INFORMATION LETTER

206L-15-100

Revision A, 28 August 2015

SUBJECT: ENGINE FOREIGN OBJECT DAMAGE (FOD), PREVENTION OF

Figure 1 - Nutplate Locations and Retaining Clip Detail

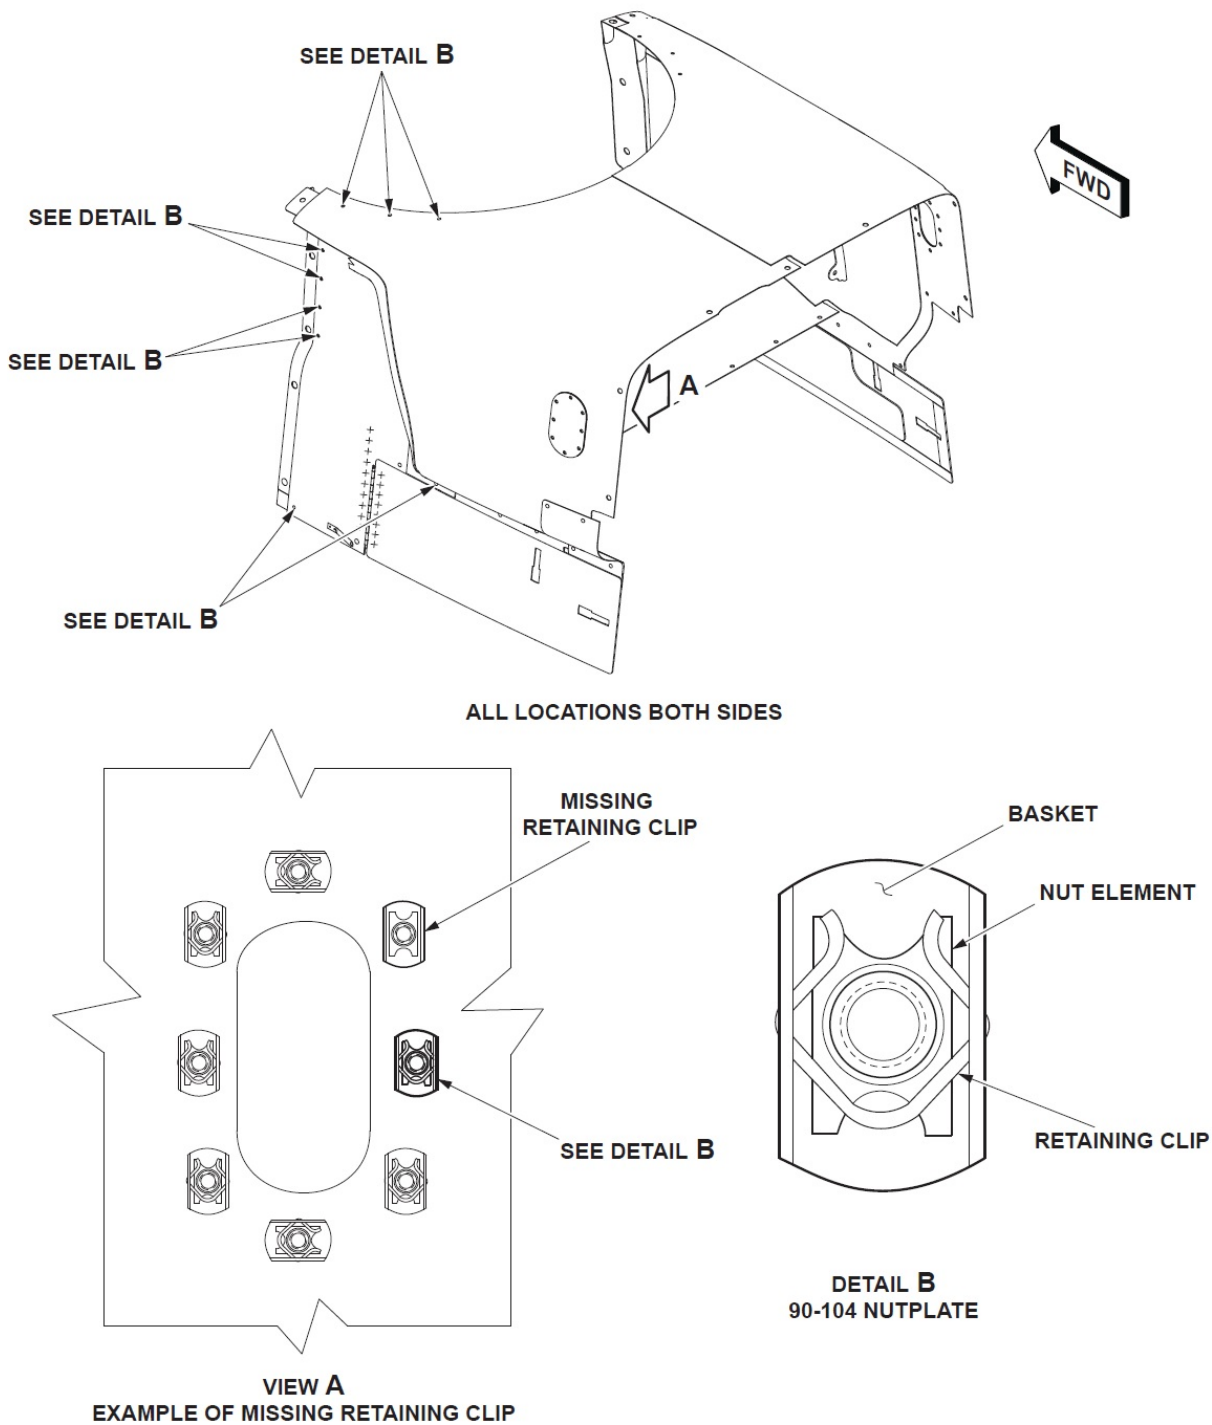
The cowlings are configured with **90-104Cxx-x** nutplates that are bonded on the inner surface. This type of nutplate is designed with a replaceable nut element that is held in place by a retaining clip. The purpose of this revision is to highlight additional locations on the cowling where this type of nutplate is used in addition to the inspection windows (Figure 1, Detail B). All locations are on both sides of the cowling.

Bell Helicopter encourages maintainers to carefully inspect the nutplates for integrity when removing/reinstalling the inspection window, snow deflector, and/or the inlet cowling itself. This practice may prevent a broken nutplate causing FOD to the engine.
